Title - Sujet Aircraft Training / Maintenance Pla	
Solicitation No. - N° de l'invitation W0125-17LM01/A	Amendment No. - N° modif. 007
Client Reference No. - N° de référence du client W0125-17-LM01	Date 2016-08-05
GETS Reference No. - N° de référence de SEAG PW-\$KIN-930-6947	
File No. - N° de dossier KIN-6-46022 (930)	CCC No./N° CCC - FMS No./N° VME
Solicitation Closes - L'invitation prend fin at - à 02:00 PM on - le 2016-08-16	
Time Zone Fuseau horaire Eastern Daylight Saving Time EDT	
F.O.B. - F.A.B. Specified Herein - Précisé dans les présentes	
Plant-Usine: <input type="checkbox"/> Destination: <input type="checkbox"/> Other-Autre: <input checked="" type="checkbox"/>	
Address Enquiries to: - Adresser toutes questions à: Littlefield, Mike	Buyer Id - Id de l'acheteur kin930
Telephone No. - N° de téléphone (613) 545-8058 ()	FAX No. - N° de FAX (613) 545-8067
Destination - of Goods, Services, and Construction: Destination - des biens, services et construction:

Aircraft Training and Maintenance Platforms

Amendment 007 is being issued in response to Bidder's questions and Canada's responses and to amend Annex "A" Statement of Work.

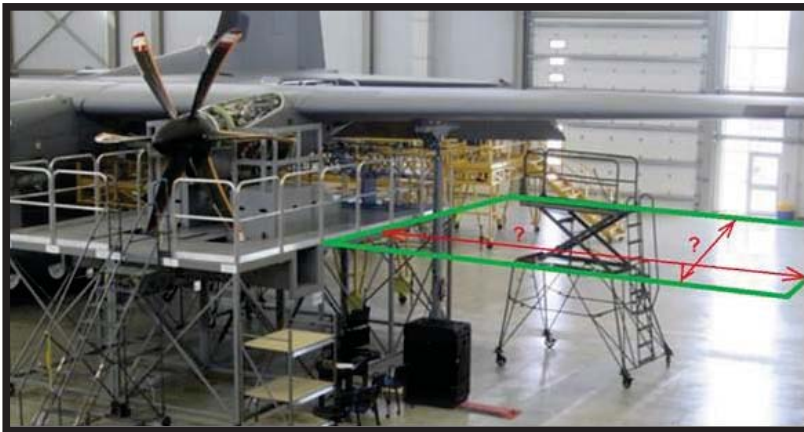
Q3. Reference is made to Amendment 004, Question #1. Please provide OWS number for this jack (see below). This will help with having a clearer understanding of necessary platform coverage.

A3. The pictured jack (Wing Steady) is located at OWS 283.000

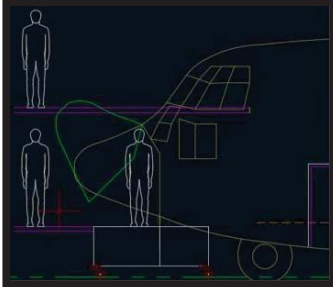
Q5. If the above is not a stand, what exactly is the required platform coverage area overboard of the fixed wing jack (see photo below)? How much forward of the wing in this area and how much aft? And does the platform need to extend from the edge of existing to 5ft past the wing tip?

- A5.** The question above does in fact refer to a stand. Requirement is that stand must extend 8 ft./2.4384 metres forward of leading edge and 8 ft./2.4384 aft of trailing edge. The platform(s) must extend from edge of existing stands to 5 ft./1.524 metres past wing tip on L/H wing and platforms must extend 5 ft./1.524 metres past R/H wingtip.
